Recall Bulletin

F/CMVSS NONCOMPLIANCE RECALL

SUBJECT: Windshield Washer Hose May Separate

MODELS: 2012 Chevrolet Sonic

Windshield Washer Bottle Designs

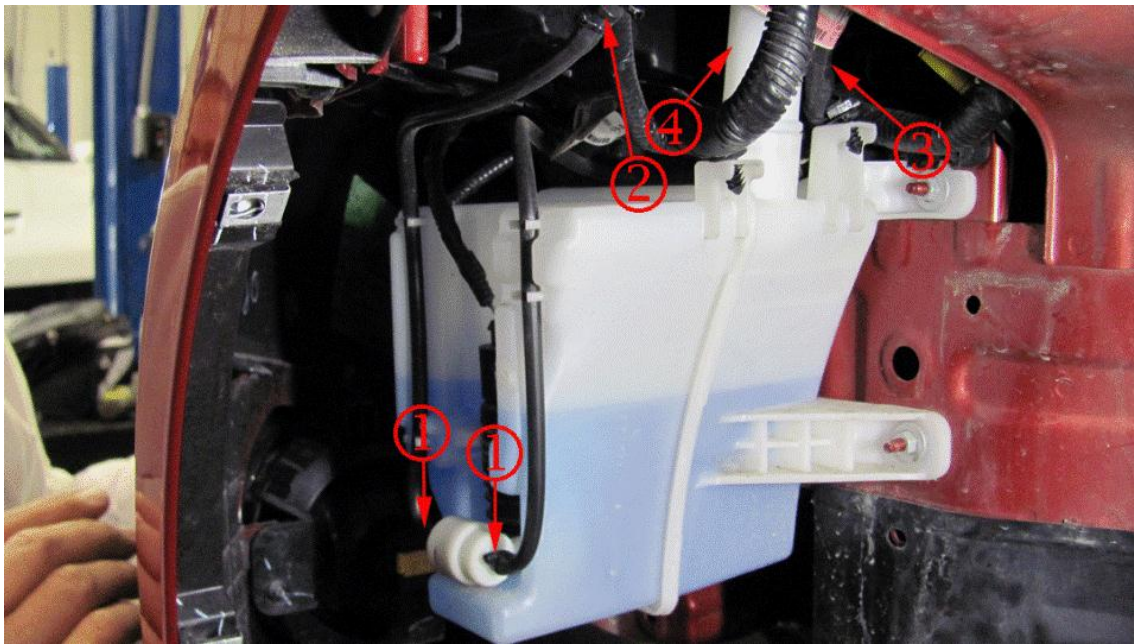
There are two different windshield washer bottle designs. Sedan vehicles (A) have a windshield washer bottle pump with one front hose. Hatchback vehicles (B) have a windshield washer bottle pump with a front and rear hose. The procedure in this bulletin includes instructions on where to install three (3) band ties on the one front hose design windshield washer bottle. In addition, the procedure in this bulletin provides instructions on where to install six (6) band ties on the front and rear hose design windshield washer bottle.

4. **“A” Sedan Vehicles:** Inspect the windshield washer bottle at the pump to determine if a band tie (1) is installed on the front hose of the pump. If a band tie (1) is not installed, install one as shown in the “A” portion of the illustration.

“B” Hatchback Vehicles: Inspect the windshield washer bottle at the pump to determine if two band ties (1) are installed on the front and rear hoses of the pump. If band ties (1) are not installed, install two band ties (1) as shown in the “B” portion of the illustration.

2896902

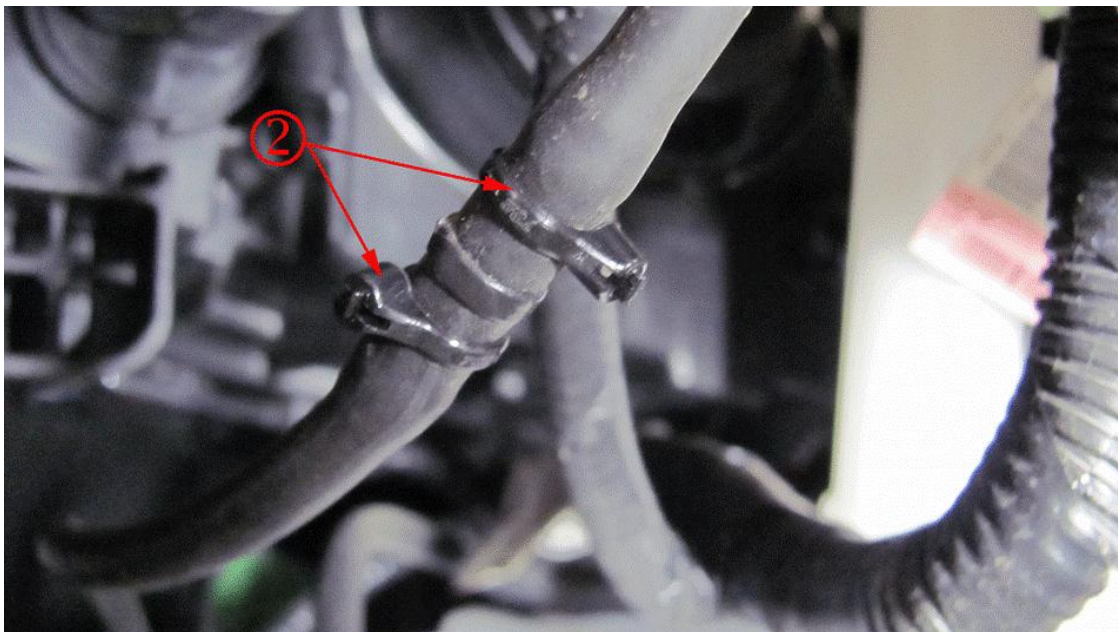
Front and rear hose windshield washer bottle design shown, front hose windshield washer bottle design is similar. (1) Pump Location (2) Front Hose Connection (3) Rear Hose Connection.

5. Install band ties at the following locations of the windshield washer bottle hoses:
 - **Sedan Vehicles:** Install 1 band tie at the pump location (1), if required, and 2 band ties at the front hose connection (2).
 - **Hatchback Vehicles:** Install 2 band ties at the pump location (1), if required, 2 band ties at the front hose connection (2) and 2 band ties at the rear hose connection (3). The windshield washer bottle neck (4) will have to be removed to gain access to the rear hose connection. Re-install the windshield washer bottle neck after installing the band ties at the rear hose connection.
6. Install the front wheelhouse liner inner front extension. Refer to *Front Wheelhouse Liner Inner Front Extension Replacement* in SI.
7. Install the front driver side (left) tire and wheel assembly. Refer to *Tire and Wheel Removal and Installation* in SI.
8. Lower the vehicle.

2897001

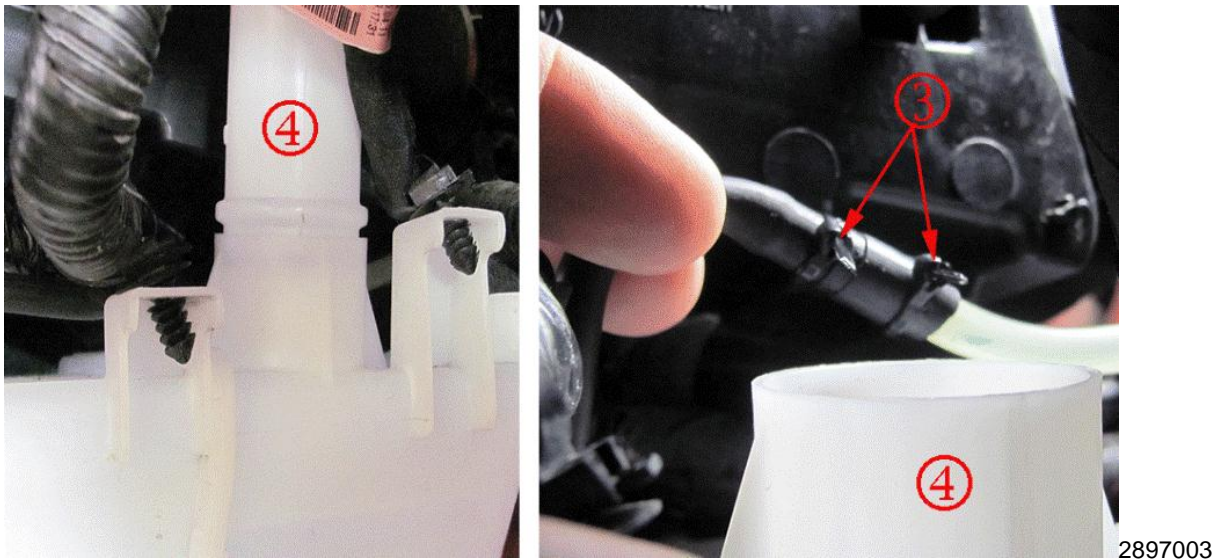
Install 2 band ties at the front hose connection (2).

To gain access to the rear hose connection, remove the windshield washer bottle neck. Turn the neck (4) counterclockwise to remove the neck (4). Install 2 band ties at the rear hose connection (3).
